UNITED STATES
NUCLEAR REGULATORY COMMISSION
REGION III
2443 WARRENVILLE ROAD, SUITE 210
LISLE, ILLINOIS 60532-4352

TELEFAX TRANSMITTAL

The following additional information is needed to review your request.

Figure E.1 Sample License Application: Facility Diagram

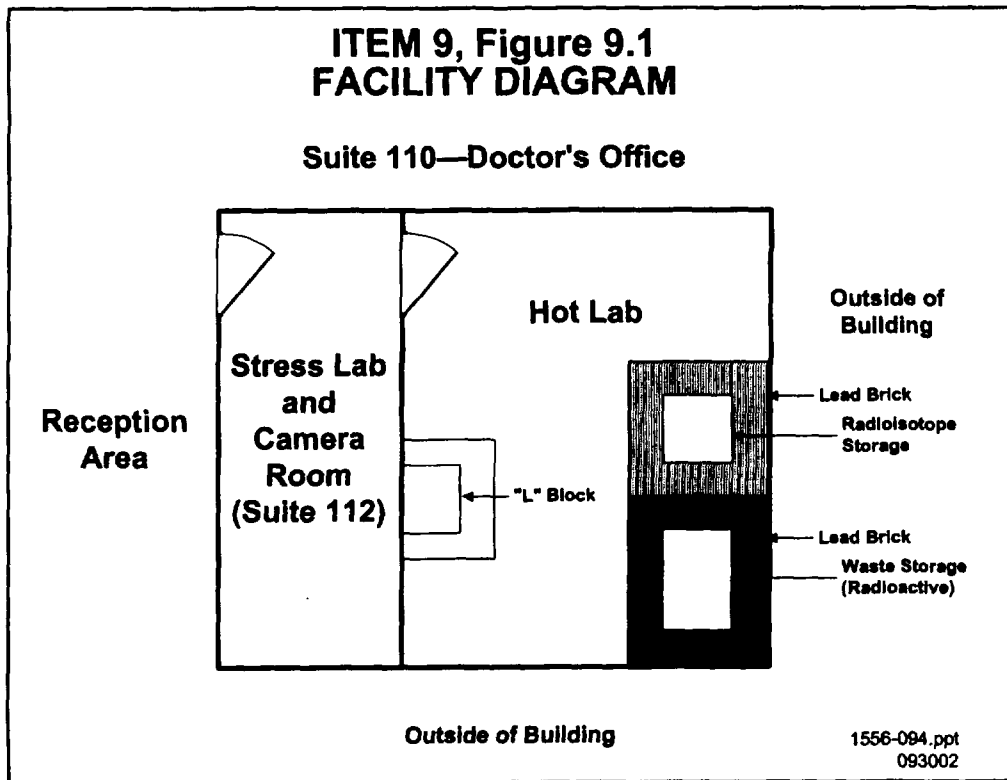
Facility Diagram

1. Please specify the room number(s) where radionuclides will be used or stored. If there are no room numbers, please state so.
2. Please specify what is above and below the rooms or areas where radionuclides will be used or stored.
